RESPONSE TO REQUESTS FOR  
ADDITIONAL INFORMATION  
NO. 2 UNIT  
SALEM NUCLEAR GENERATING STATION  
DOCKET NO. 50-311

SALEM NUCLEAR GENERATING STATION  
UNIT NO. 2  
NRC SEISMIC QUALIFICATION REVIEW  
RESPONSES TO ADDITIONAL INFORMATION REQUESTS

FIGURE 1

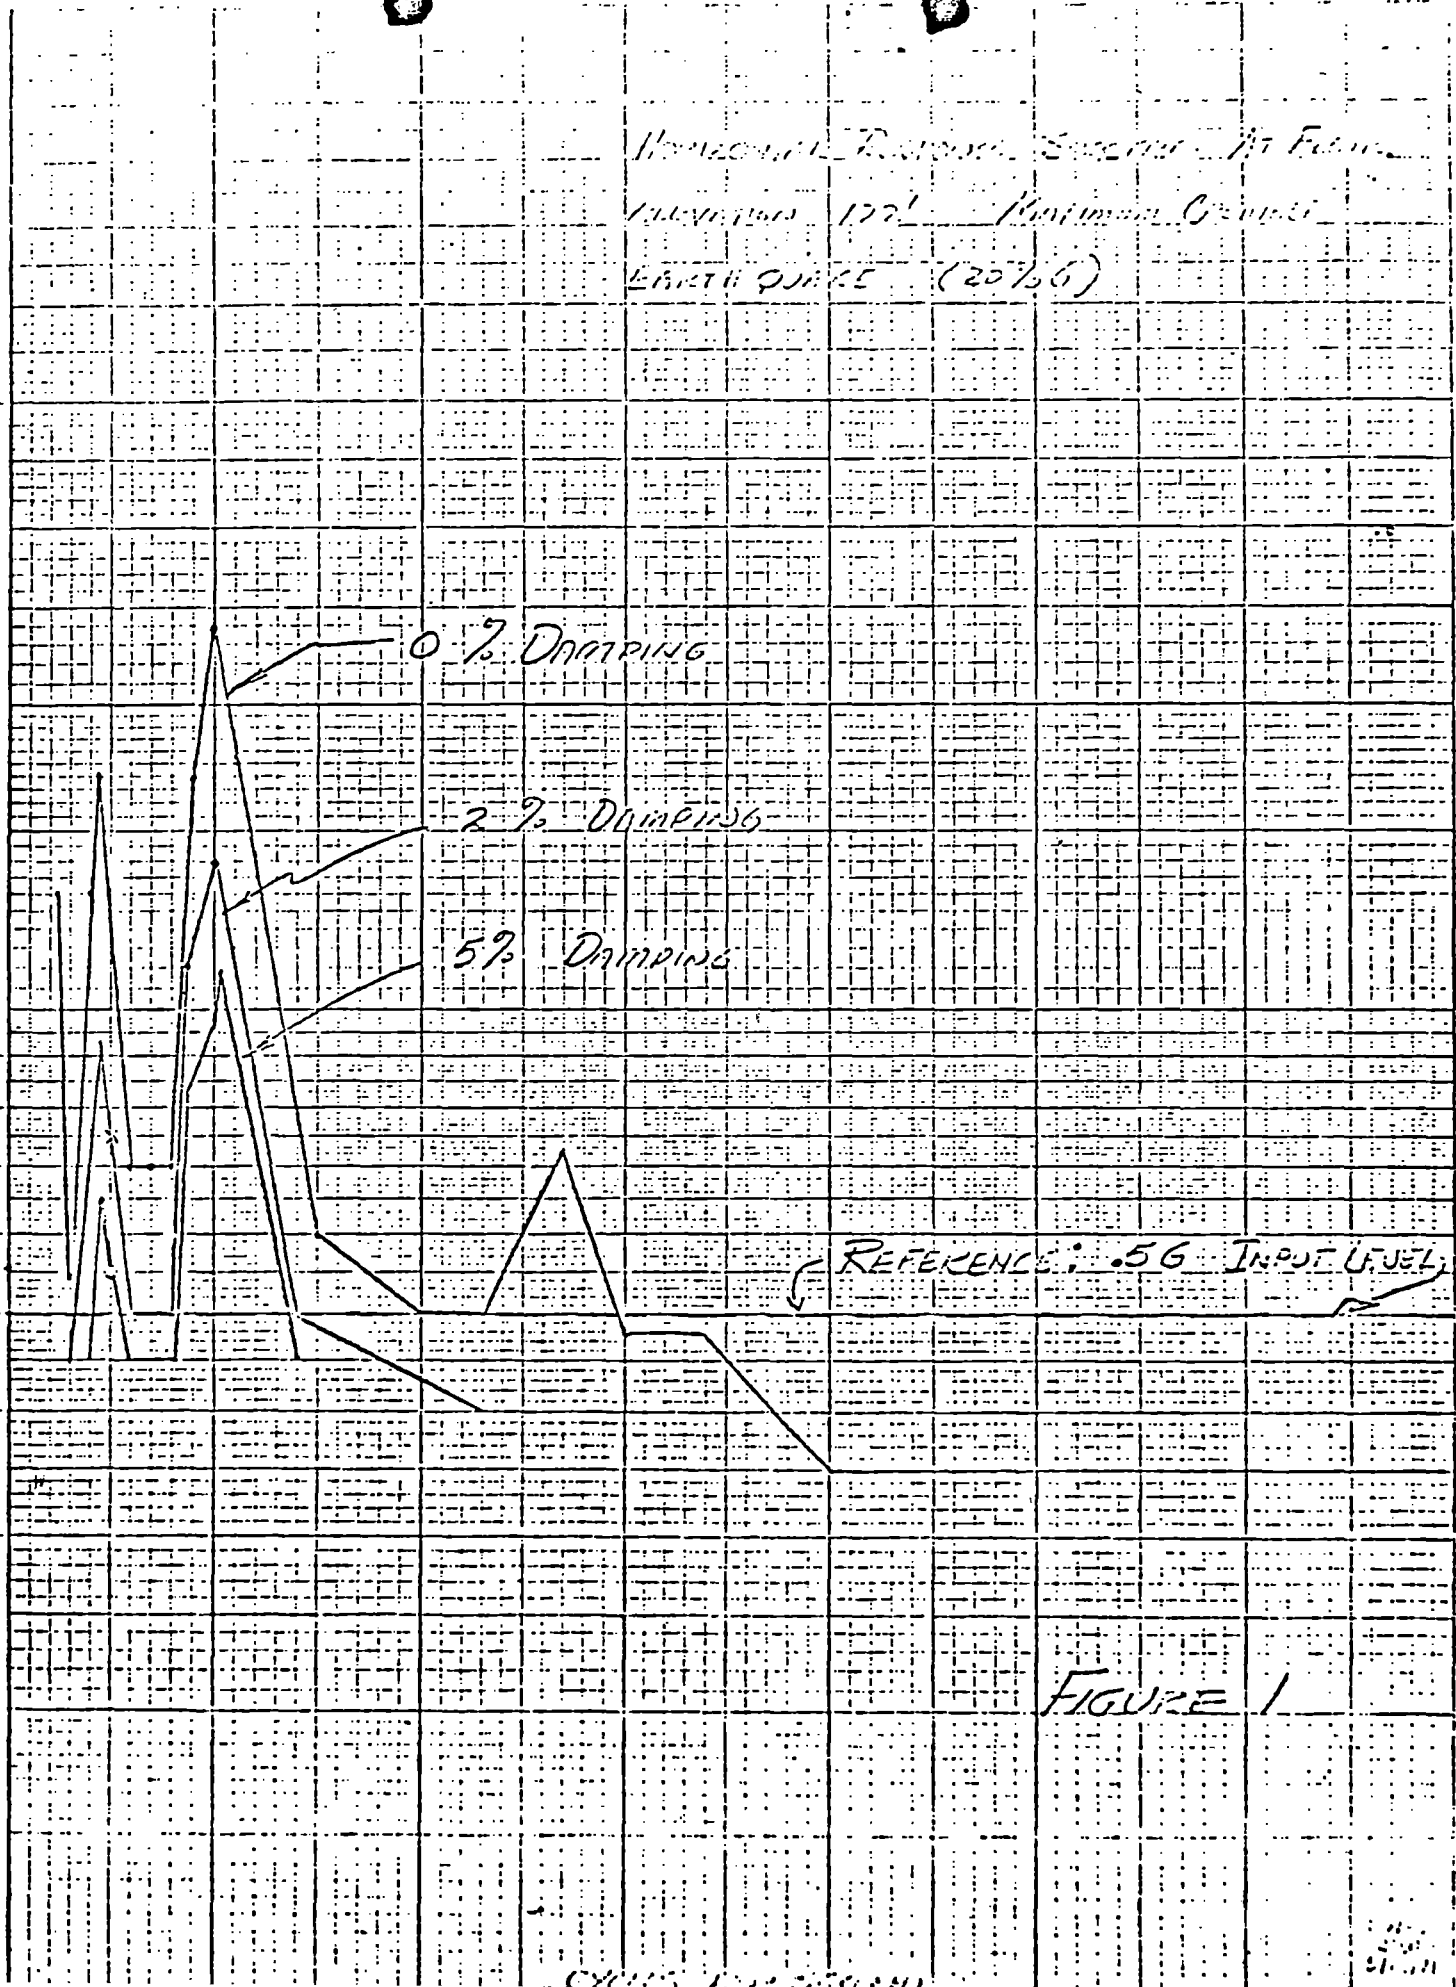
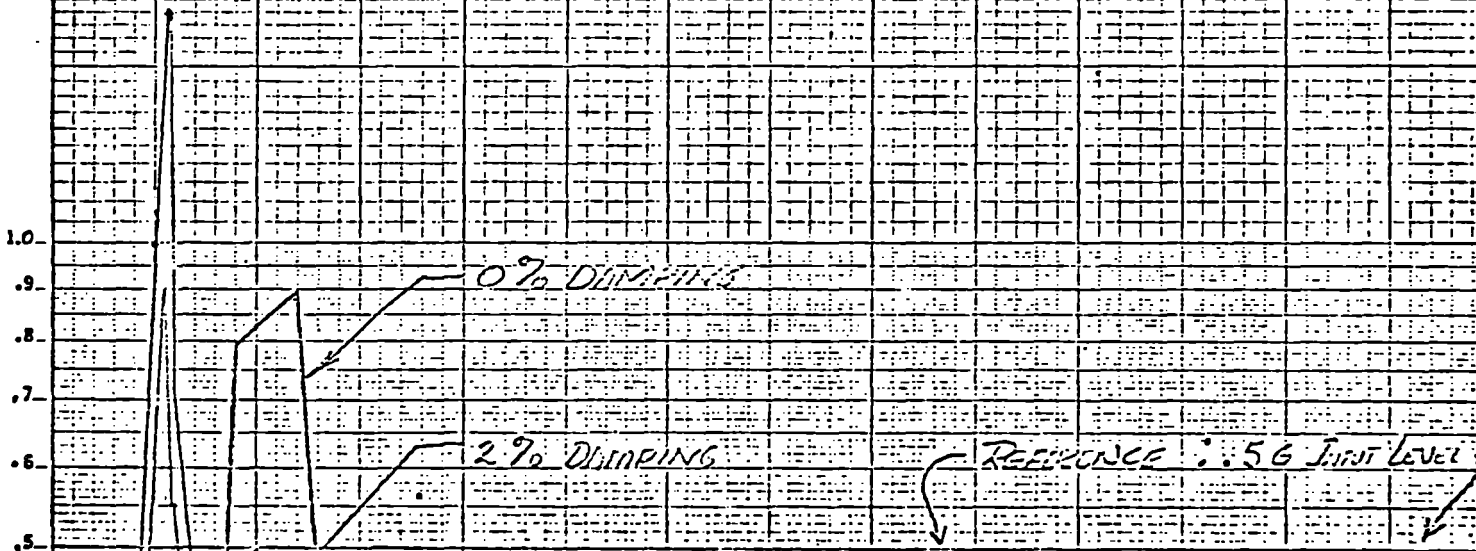
The only question about the data was how accurate was the extrapolation of the test results from 5 to 10 Hz. In this frequency range the input G level was only approximately .25 G. Since this was also near the resonant frequency in the horizontal direction, the extrapolation might not be justified from a reliability standpoint.

One question which must be answered is how well the test depicts the satisfactory operation of the unit under upset conditions. The horizontal and vertical response spectra curves give an indication of expected input "G's" as a function of frequency for the maximum credible earthquake (20% G horizontally and 13.3% G vertically)

and design base earthquake (10% horizontally and 6.7% G vertically). This data shows that for vertical response the input levels will be less than .5 G as long as the damping is 2% or greater. For the horizontal response the input levels will be greater than .5 G's for both the maximum credible earthquake and the design base earthquake. These curves have been replotted (Figures 1 and 2) to illustrate the frequencies that the input levels exceed .5 G. Figure 1 indicates that the input level could be 1.1 G at 5 Hz and 2.4 G at 10 Hz. Figure 2 shows that the G level of 1.0 G at 5 Hz and .9 G at 12 Hz exceeded the .5 G input test level. The significance of these facts are: (1) the motor control unit could be subjected to more severe vibrations than those to which it has been tested, assuming that the damping is less than 5%, and (2) the maximum response corresponds to the natural frequency of the motor control unit, which is undesirable."

The input amplitude between 5-10 hz represents machine capabilities in this frequency span. A maximum transmissibility factor of 3:1 between the base of MCC and the motor starters was determined. Individual tests conducted separately on motor starters indicated that they could withstand considerably more than  $0.5 \times 3 = 1.5$  g's, so that the analysis is substantiated.

Individual components have been tested by themselves and found to withstand over 6g's force in all three planes without malfunction. The structure and components can stand considerably more than these forces without damage, and operate normally on return to normal condition.

The MCC bolted structure is, by design, a good shock absorber. With the transmissibility measured, the damping factor is actually greater than 5%.

FIGURE 4-2  
MOTOR CONTROL CENTER - ACCELEROMETER MOUNTING LOCATION

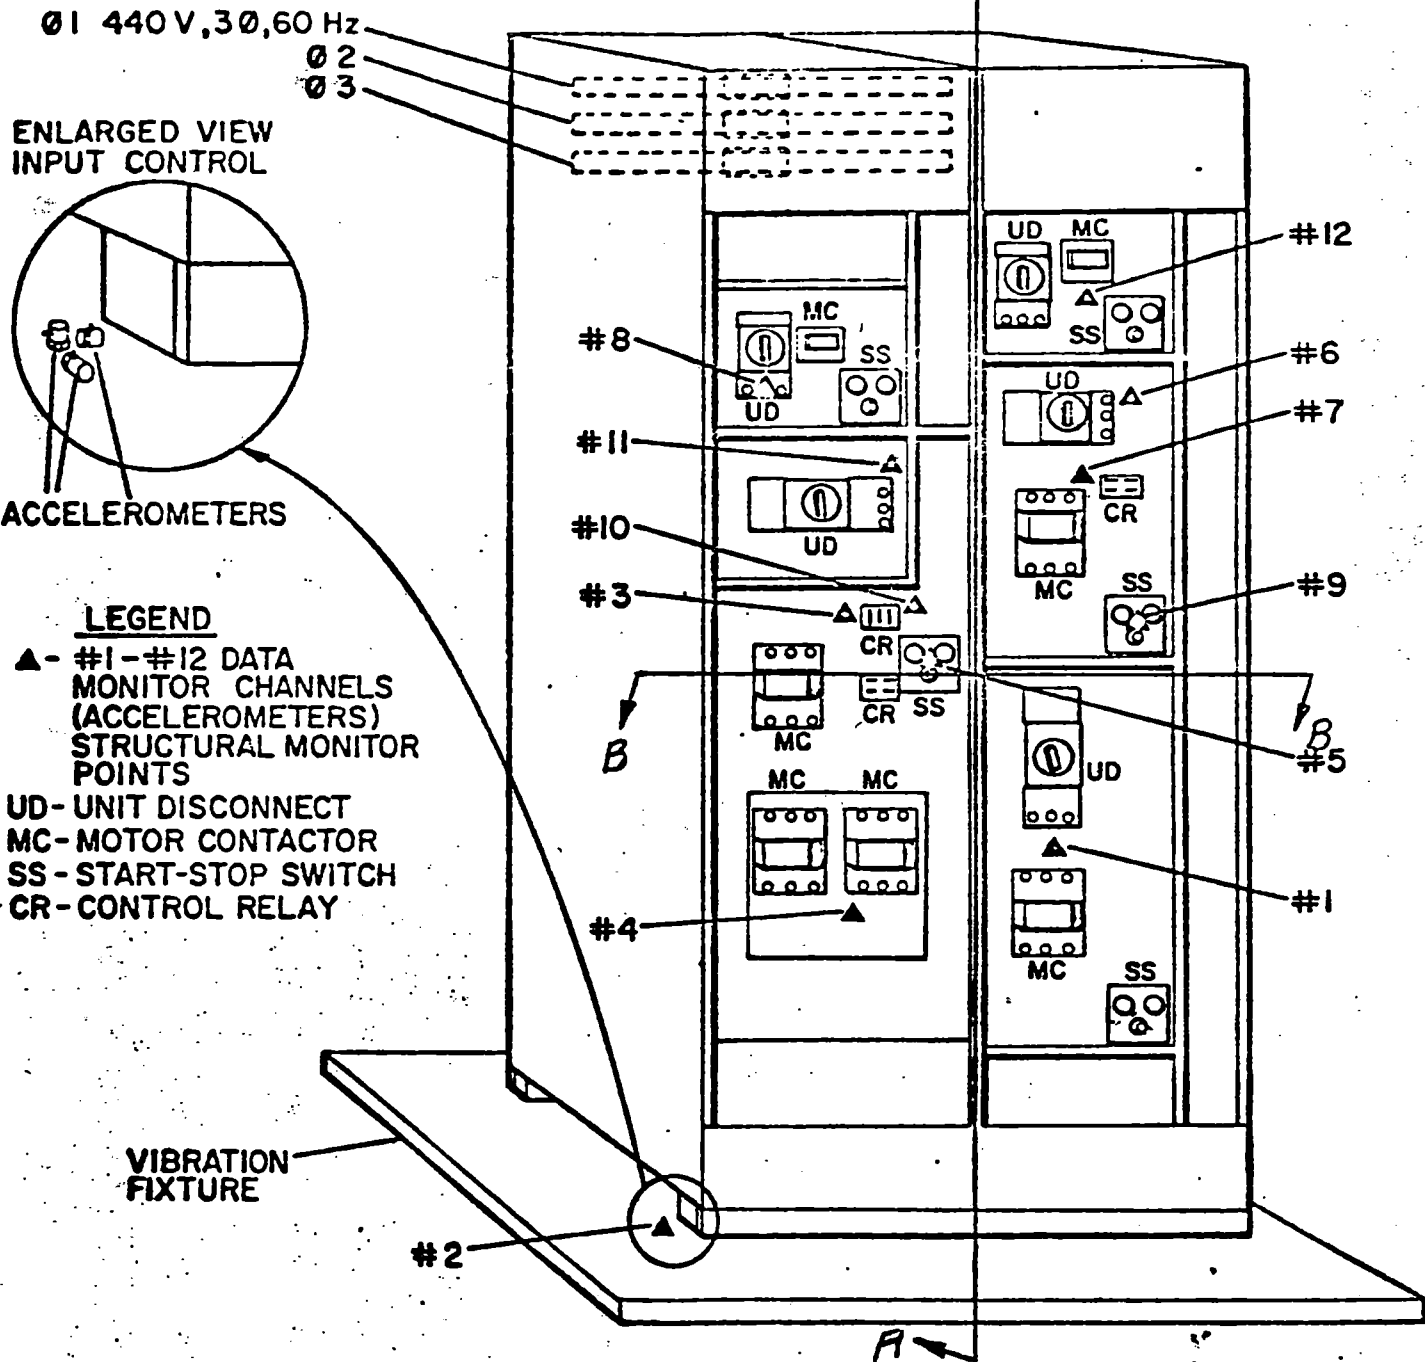
- b. Area of Concern: Clarify the input accelerometer data used to monitor test input on General Electric Test Report 70ICS100.

Response: As stated in Test Report 70ICS100, the input accelerometer used in this test was designated as #2 on figure 4-2 (Attachment 4). Table 3-4 of the report (Attachment 5) indicates the specific pages which provide the input data for this accelerometer (e.g. pages 1A, 13A and 25A). These pages are included at attachments 6, 7 and 8 respectively.

FIGURE NO. 2

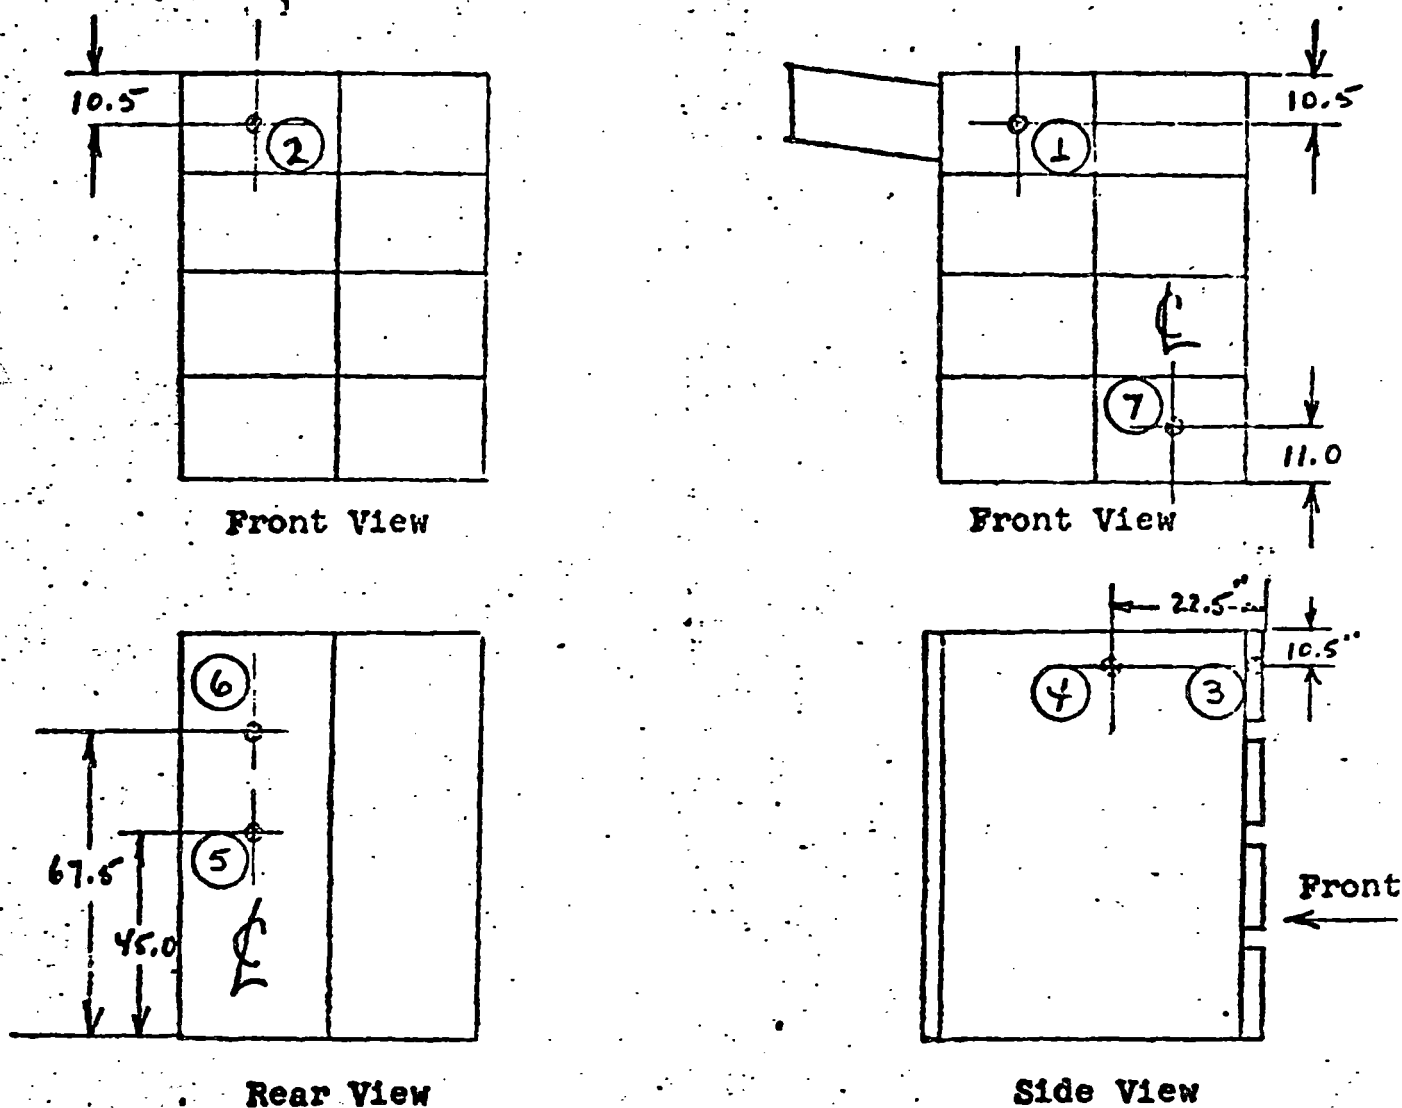
- a. Area of Concern: Provide additional information regarding effect of resonances identified in ITE Test Report #R-8792.

Response: The resonant conditions identified in the report occurred only on the sheet metal surfaces. ITE Test Report #R-8792 prepared by Applied Devices Corporation states that there were no appreciable resonant conditions of the structure frame itself. (See attachments 9 & 10).

Unlike the ITE unit tested there are no relays in any of the safety related 600V switchgear at Salem Generating Station, nor are any required to perform a safety function. Therefore, the high transmissibility of the sheet metal surfaces would not affect the operation of the 600V switchgear during a seismic event.

Portion of PSE&G DWG. 223680-AL-7000  
Diesel-Generator Unit Trip Protection

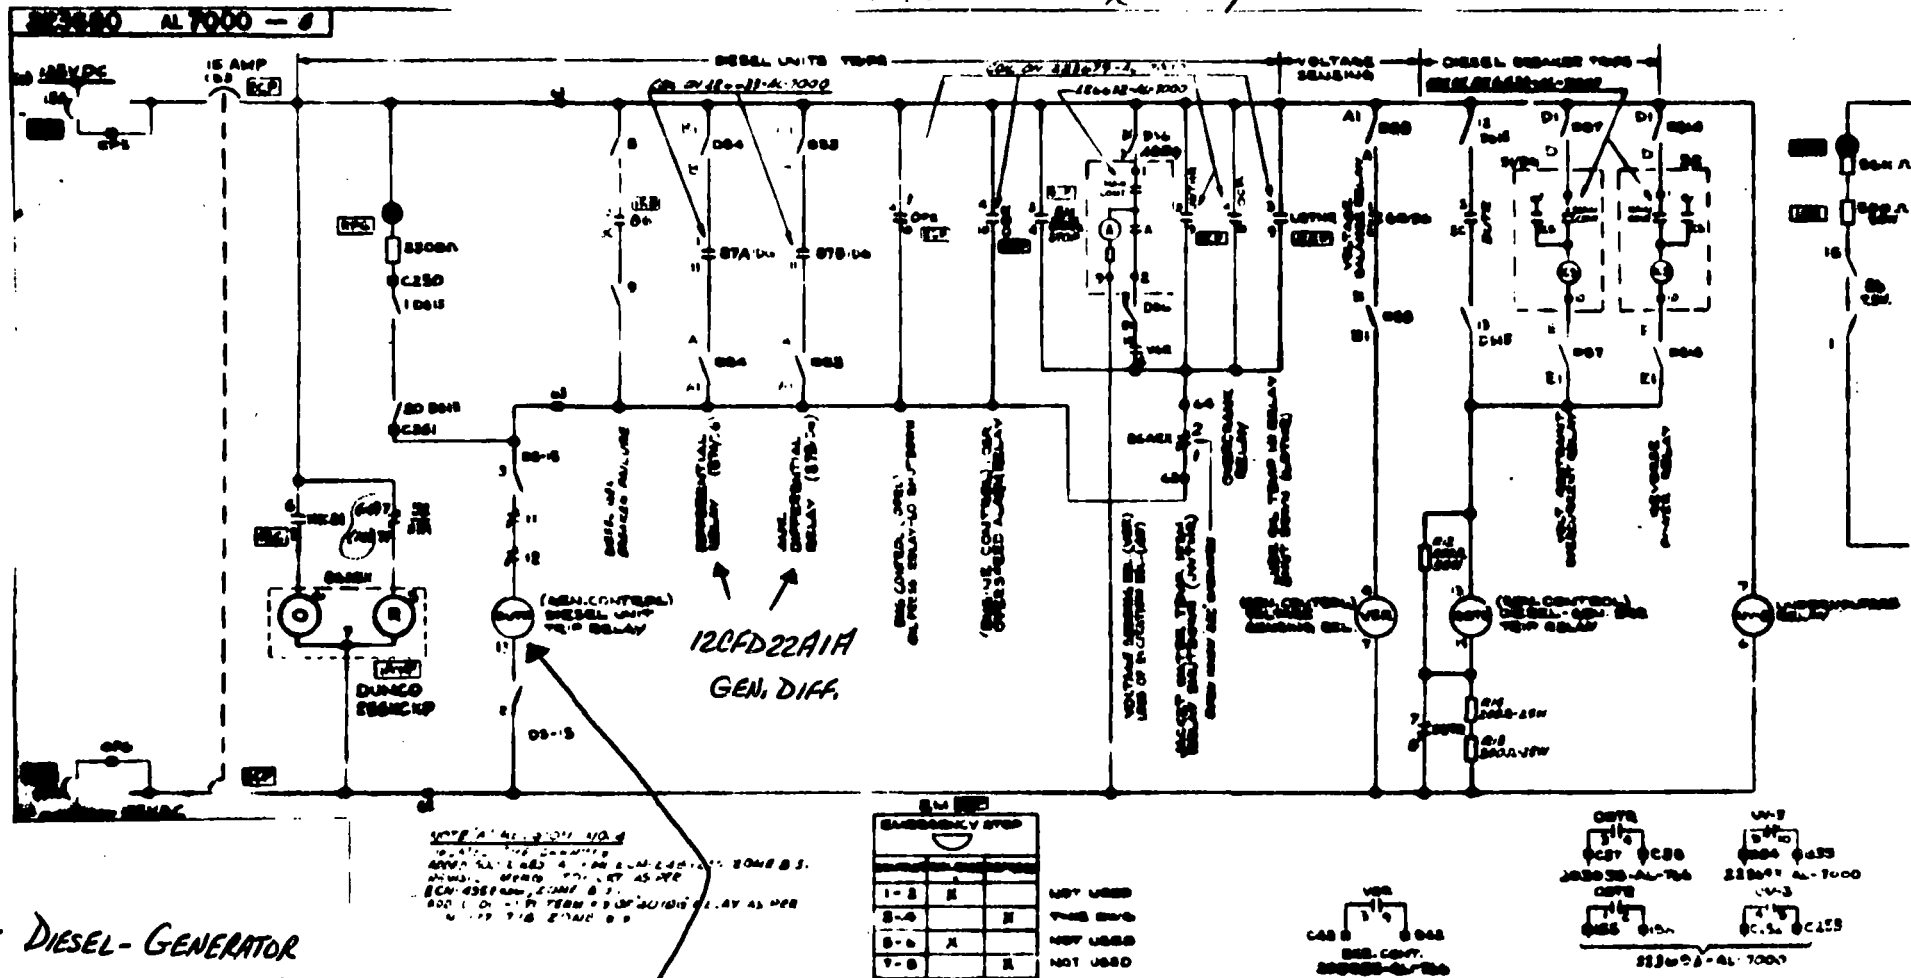
- a. Area of Concern: Provide information regarding the functional operability of the diesel-generator differential protection relay 12CFD22A1A during the seismic test of the generator control panel (Wyle Report 42551-1).

Response: During the seismic test of the generator control panel, a number of relays were monitored for operability. The diesel-generator differential protection relay 12CFD22A1A is in the circuit for the diesel unit trip relay (DUTR). Refer to attachment 11 for a portion of the circuitry. The DUTR circuit was energized and monitored during the seismic test. Unacceptable operation of the CFD relay would have tripped the DUTR. The DUTR did not trip during the test which signifies that the input relays to the DUTR did not misoperate. Pre-operational and post-operational testing of the DUTR verified its operability. The acceptable operation of the DUTR provides acceptance of the diesel-generator differential protection relay.

The DUTR Relay was energized and monitored during the seismic test (125V DC was supplied at terminals CP5 and CP6 thereby energizing the entire circuit). There was no any misoperation of the DUTR which indicates the proper performance of the generator differential relay.
